PG&E Letter DCL-21-034

Docket No. 50-275, OL-DPR-80
Docket No. 50-323, OL-DPR-82
Diablo Canyon Units 1 and 2

Response to Request for Additional Information on Final Supplemental Response to
Generic Letter 2004-02

Figure 2-1: Illustration of a laterally restrained DEGB jet

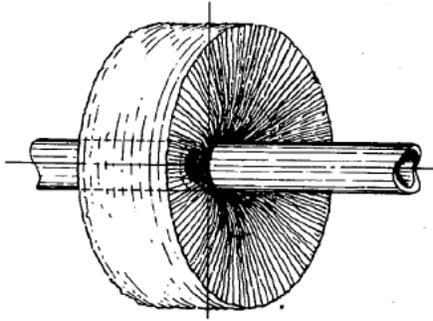
Provide an overview of the analysis method for the Temp-Mat ZOI "length" for the hot and cold-leg nozzle breaks. Also, describe how the break geometries and sizes were determined and how these geometries relate to the assigned ZOI volumes.

ANSI/ANS-58.2-1988 laterally restrained double-ended guillotine break (DEGB) jet model. This approach is reasonable because the shape of the jet resulting from this configuration will not be significantly affected by the slight radial offset. The flow from one end of the ruptured pipe will not escape in the axial direction past the outside surface of the opposite pipe, and the jet will continue to form radially. The jet configuration is illustrated in Figure 2-1.
